Report: TAB Report
Function: Test, Adjust, & Balance
Date: 05/31/2024

PROJECT
06-03-24 WAWA #5434 PALATKA, FL

Project: 06-03-24 WAWA #5434 PALATKA, FL

EF_2
06/13/2024

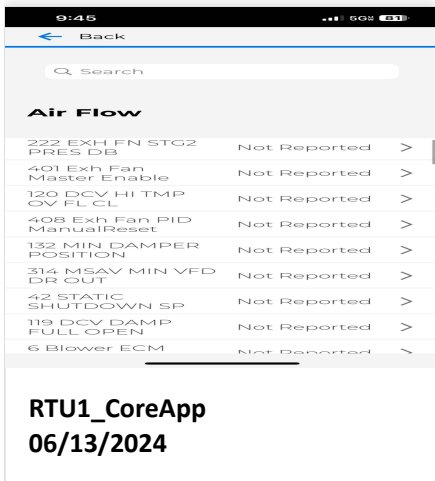
Issue Name : EF 2 Not Running
Description : EF 2 serving the Water Service Room, was not running at the time of balance. This fan was not balanced. The operation of this fan will not effect the balance or comfort of the rest of the store.
Created By : National TAB **Assigned To :** National TAB - Will Turnbough
Status : Open
Priority : High **Asset Tag :**
Originated Date : 06/13/2024 - Stephen Tassinaro - National TAB

**MissingFilter
06/05/2024**

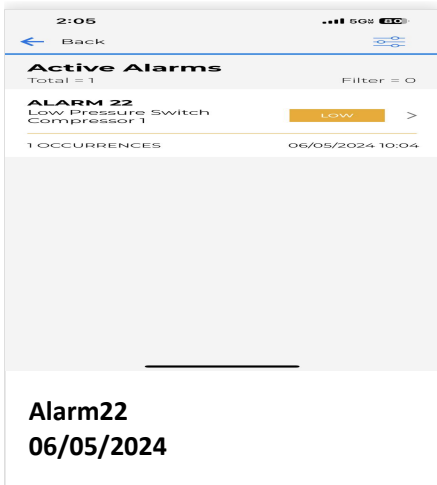
Issue Name : RTU 2 Missing One Final Filter
Description : RTU 2 is missing one of the final filters. Recommend replacing.
Created By : National TAB **Assigned To :** National TAB - Will Turnbough
Status : Open
Priority : Medium **Asset Tag :**
Originated Date : 06/05/2024 - Stephen Tassinaro - National TAB
